Beck North Lot 53 JSP14-03

Consideration of the request of Amson Dembs Development for Preliminary Site Plan and Stormwater Management Plan approval. The subject property is located in Section 4, at the northeast corner of Nadlan Court and Hudson Drive in the I-1, Light Industrial District. The subject property is 3.90 acres and the applicant is proposing to construct a 50,058 square foot speculative office and industrial building with associated parking and landscaping.

Approval/denial of the Preliminary Site Plan and Stormwater Management Plan.

PLANNING REVIEW

AMSON DEMBS DEVELOPMENT, INC.
PRELIMINARY SITE PLAN
 BECK NORTH CORPORATE PARK - UNIT 53
 SECTION: 4
 TOWNSHIP: 1 N
 RANGE: 8 E
 CITY OF NOVI
 OAKLAND COUNTY
 MICHIGAN

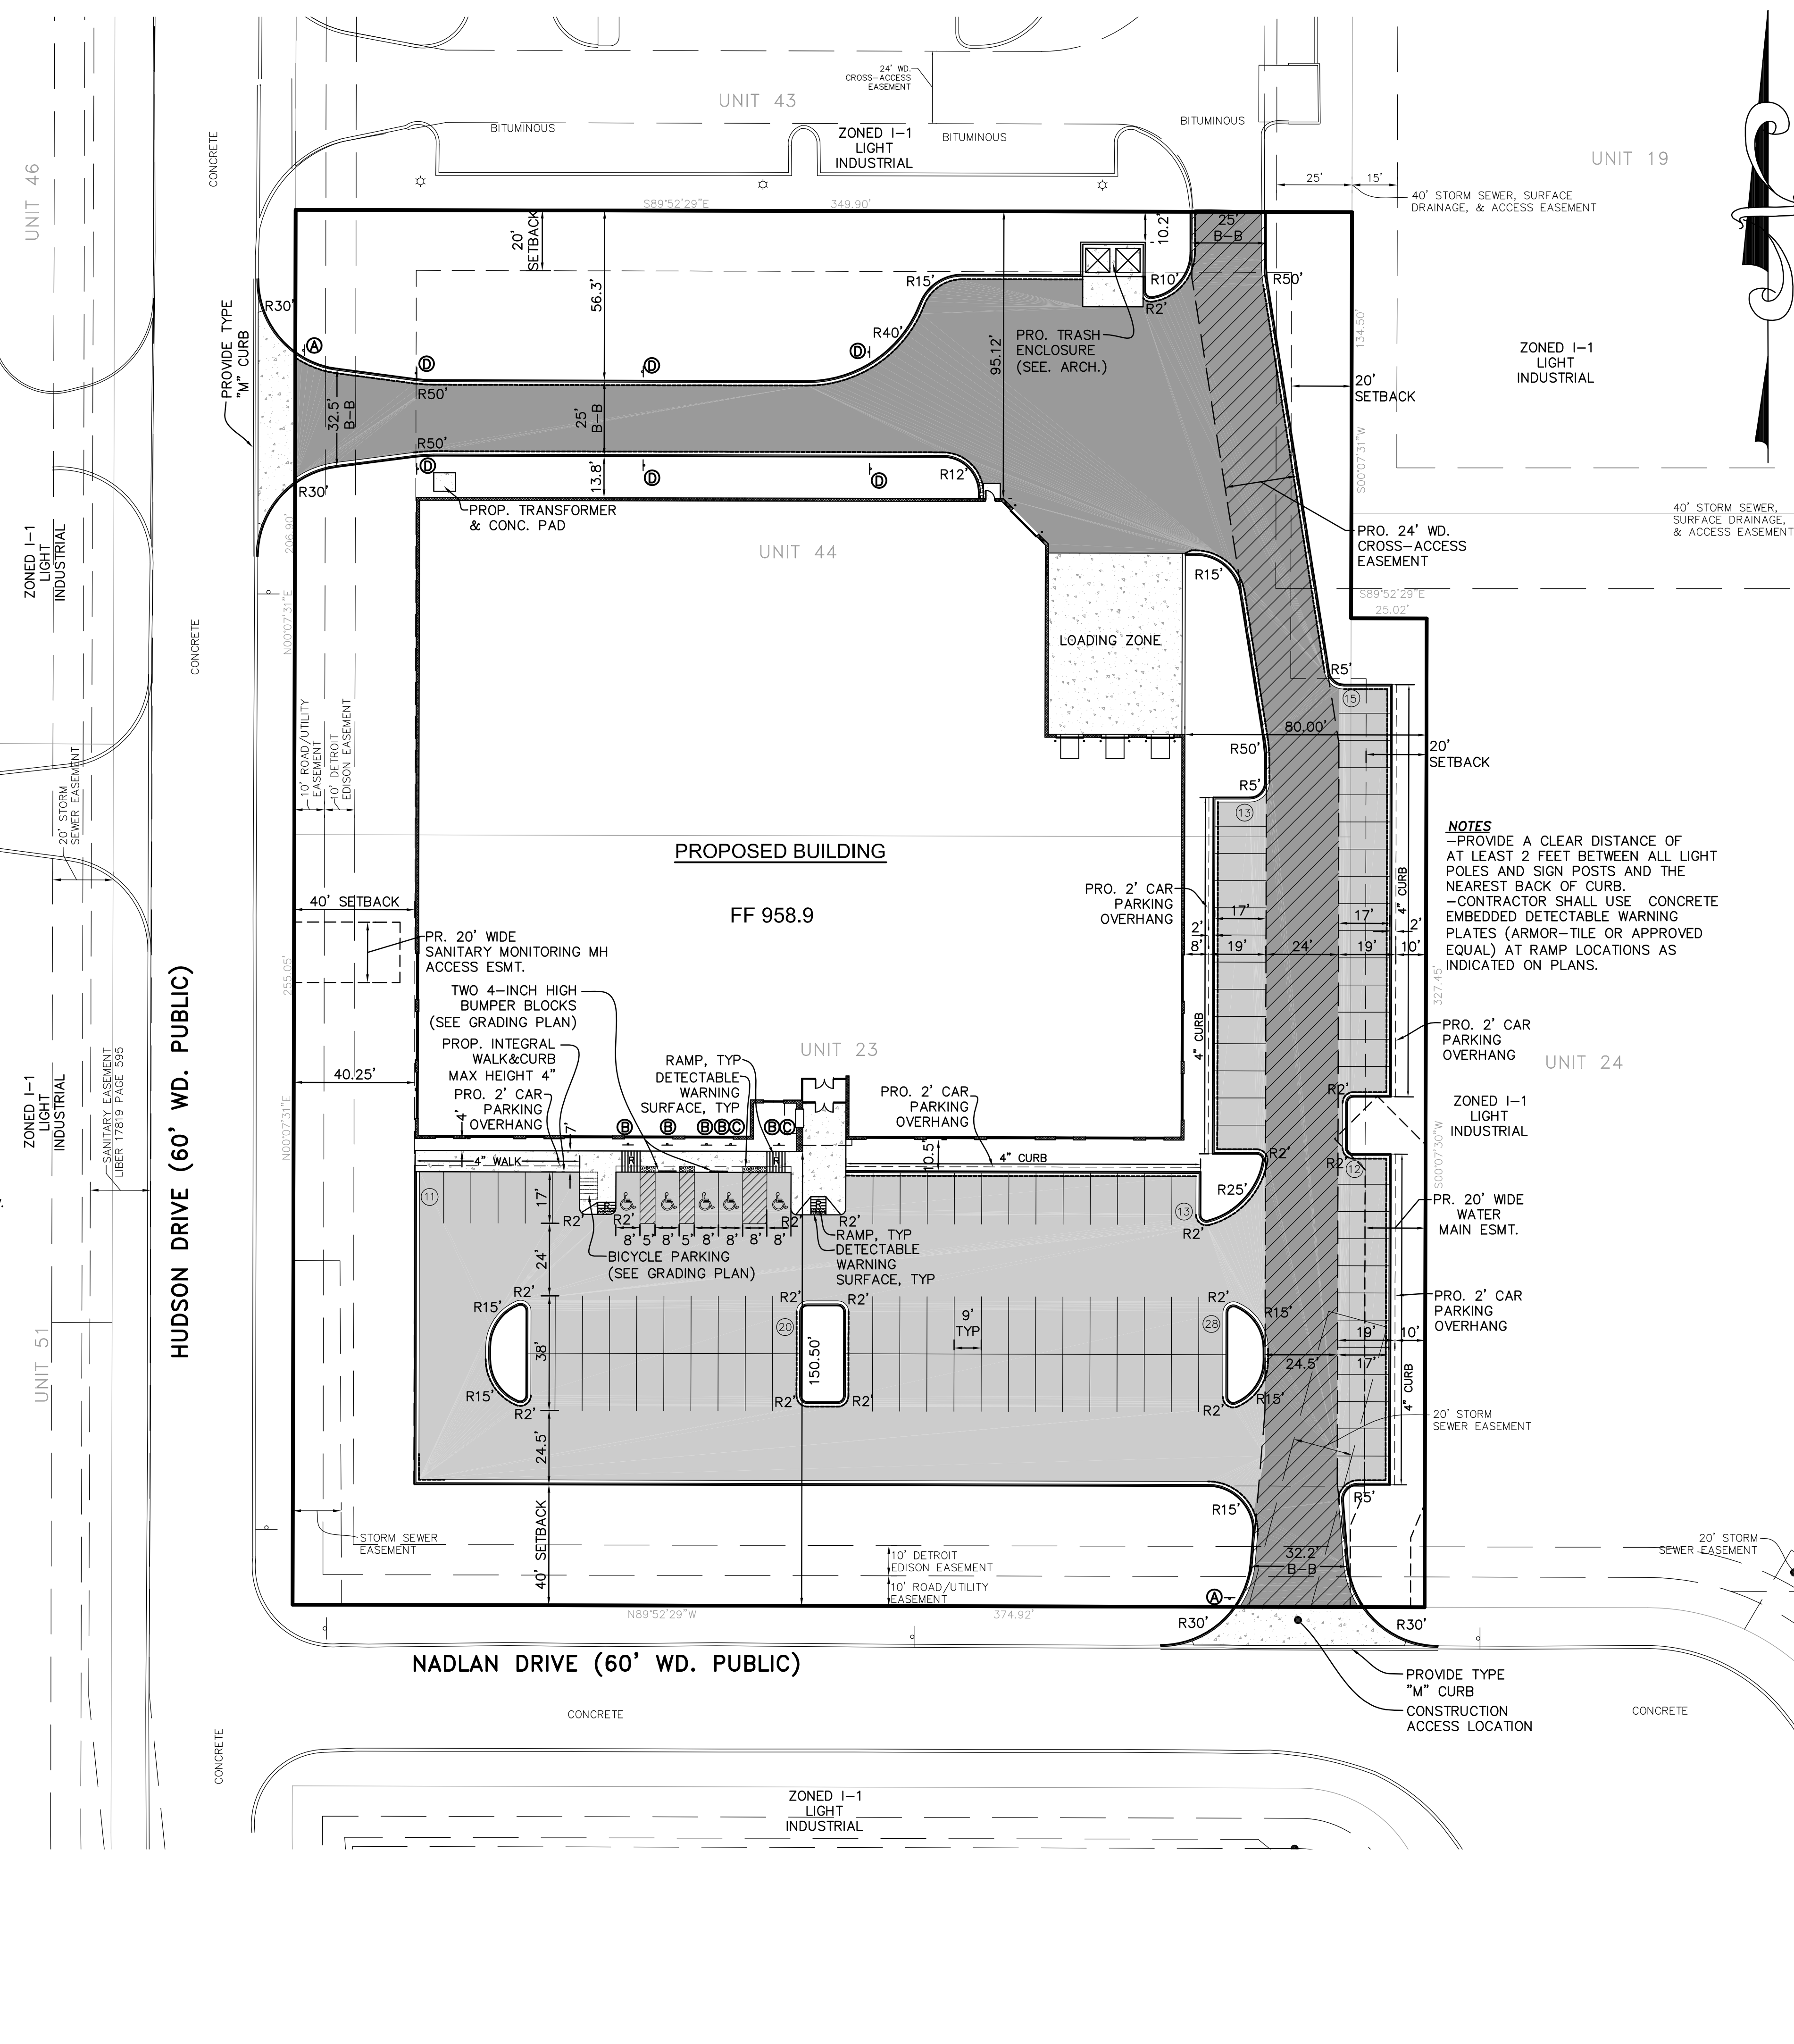
7. The Traffic Signing and Striping Requirements, listed on plan sheet 2, should be refined to more explicitly reinforce current MMUTCD guidelines. Specifically:

- a. **Note 3 should change the word “markings” to the word “striping” (see comment b, below). Also, another sentence should be added to note 3, stating that “Where a handicapped parking space abuts a non-handicapped space, the two spaces shall be separated by abutting blue and white stripes.”**

- b. **A note should be added stating that each International Symbol of Accessibility (wheelchair) to be painted on the pavement shall be white.**
 - c. Note 4 should be made more general, since it applies to all end parking spaces adjacent to sidewalks and landscape areas, not necessary just end islands. We suggest new wording as follows: **“An end parking space abutting a curb or walk should be 8 ft wide if designated a handicapped space or 9 ft wide if not. Per general site note 15, these widths are referenced to the face of curb or walk.”**

PRELIMINARY FLOOR PLAN 1
SCALE: 1/16" = 1'-0"

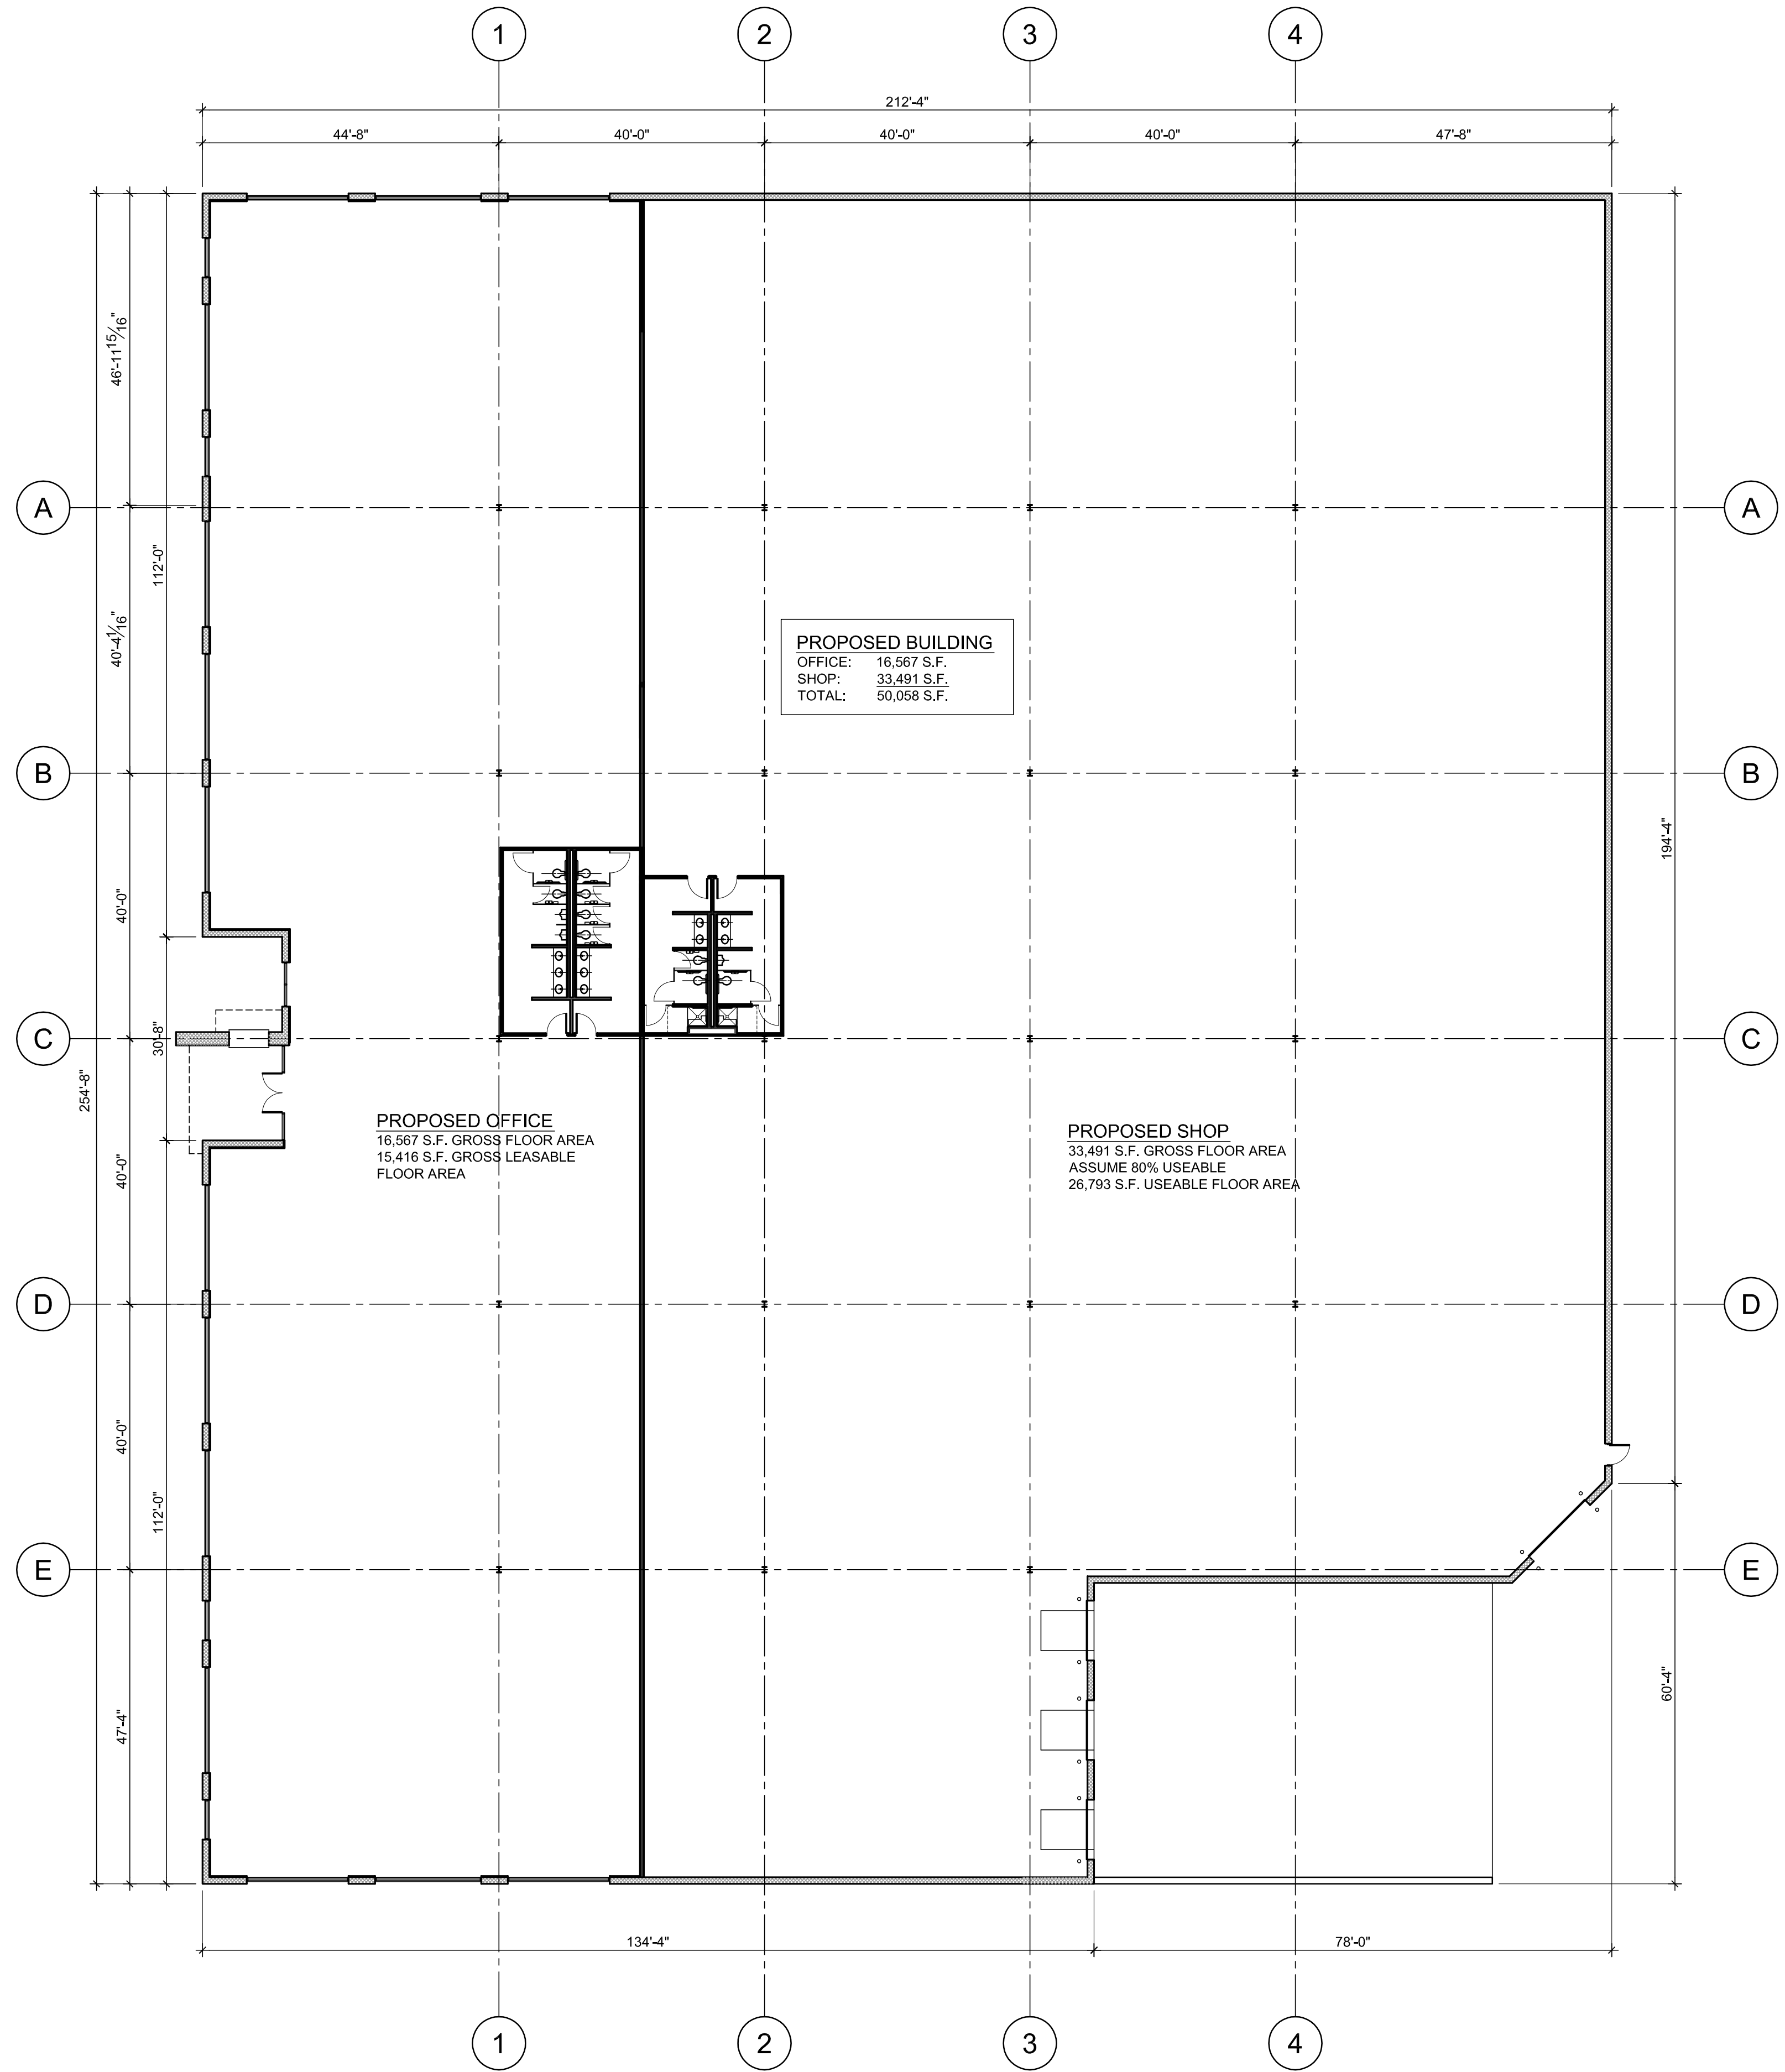
1. Required Parking: **The applicant should provide five additional parking spaces or additional detail on the floor plan showing areas that can be deducted from gross leasable and useable floor area calculations (such as storage or mechanical rooms) in order to comply with parking requirements.** The applicant should note that floor plans can be altered and approved administratively once a building tenant is identified. Alternately, the applicant could seek a variance from the Zoning Board of Appeals.

1. Additional detail will be provided on the floor plan showing areas that can be deducted from gross leasable and useable floor area calculations (such as storage or mechanical rooms) in order to comply with parking requirements.
2. Revised master deed will be submitted for review.
